Access Compliance Report

Public Rights-of-Way

(Curb Ramps)

Intersection ID: 11483	Main Street: E_17TH_ST	Cross Street: N_CALDWELL_ST	Location: S
ADA ID: FEF0957EE36D	Ramp Type: PerpDiag	Initial Pass/Fail: Fail	Overall Compliance: No
		Severity Score: 35

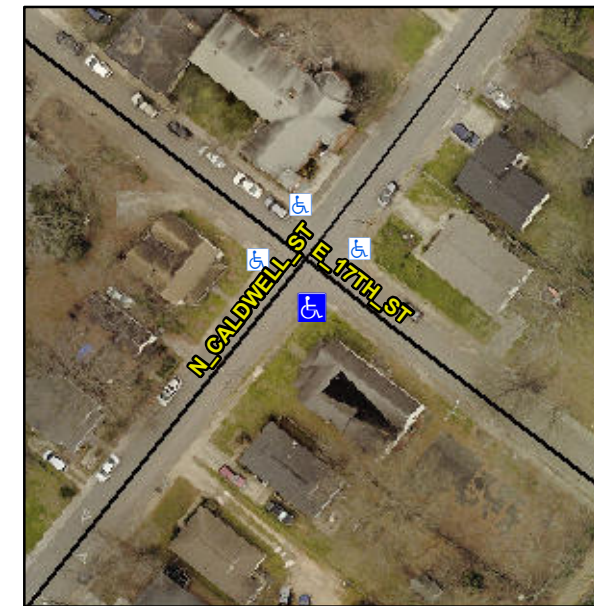
Not Found, R304.5.1, R304.2.2, R304.5.3

Compliance	Description	Data	Compliance	Description	Data
N/A	Ramp Length (in)	53.0	No	Ramp Slope (%)	13.3
No	Ramp Width (in)	38.0	No	Ramp XSlope (%)	4.8
N/A	Flare Type LT	N/A	N/A	Flare Type RT	N/A
N/A	Flare Slope LT (%)	N/A	N/A	Flare Slope RT (%)	N/A
N/A	Flare Traversable LT?	N/A	N/A	Flare Traversable RT?	N/A
N/A	Landing Length (in)	N/A	N/A	DWS Provided?	N/A
N/A	Landing Width (in)	N/A	N/A	DWS Contrast?	N/A
N/A	Landing Slope (%)	N/A	N/A	DWS Length (in)	N/A
N/A	Landing X Slope (%)	N/A	N/A	DWS Full Width?	N/A
N/A	Landing Curb? (Y/N)	N/A	N/A	DWS Offset (in)	N/A
N/A	Shared Landing?	N/A			
N/A	Gutter Ponding?	N/A	N/A	Gutter Slope (%)	N/A
N/A	Gutter Lip Ht (in)	N/A	N/A	Gutter X Slope (%)	N/A
N/A	Painted X Walk1?	No	N/A	Painted X Walk2?	No
	X Walk 1 Direction	To NE		X Walk 2 Direction	To NW
N/A	X Walk 1 Width (in)	N/A	N/A	X Walk 2 Width (in)	N/A
	X Walk 1 Slope (%)	8.2		X Walk 2 Slope (%)	1.3
	X Walk 1 X Slope (%)	0.4		X Walk 2 X Slope (%)	5.2

Remove & Replace Curb Ramp With Two New Directional Ramps or Equivalent.
